# Land-Rover Service Newsletter Vol. 3 No. 10

January 1970

The Rover Company Limited Service Department: Solihull, Warwickshire, England

**Fig. 1. Tightening cylinder head bolts**

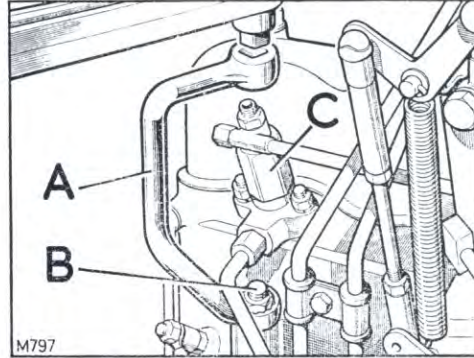
- Item 85** SUBJECT: **CYLINDER HEAD BOLTS**
- MODELS: Land-Rover 2 $\frac{1}{4}$  litre Diesel, Bonneted and Forward Control models.
- MODIFICATION: Introduction of special ring spanner for tightening cylinder head bolts.
- PART NUMBER: Ring spanner, for cylinder head bolts .. .. . 1 606445
- REMARKS: At the 1,000 miles (1500 km) free service, and after having removed and refitted the cylinder head, it is essential that the torque loading of the cylinder head fixings be checked, and if necessary reset with the engine thoroughly warm. Failure to do so may cause stresses to the cylinder head, leading to cylinder head cracking. See also News Letter Vol. 2. No. 34, item 172.

This special ring spanner has been designed to tighten the cylinder head bolts adjacent to the injectors without the need to remove the fuel injection system. Distributors and Dealers should obtain this tool, which reduces considerably the time required to carry out this operation.

- A—Special ring spanner, Part No. 606445
- B—Cylinder head bolts
- C—Injector

The time allowed for checking and adjusting the torque loading, including checking and adjusting tappets, using the new ring spanner, is 0.8 hours.

It should be noted, however, that this applies only to injectors with flange fixing. See News Letter Vol. 2, No. 30, item 143. On early engines with injectors retained by clamps, it is necessary to disconnect the pressure pipe from the injector to gain access to the cylinder head bolt.
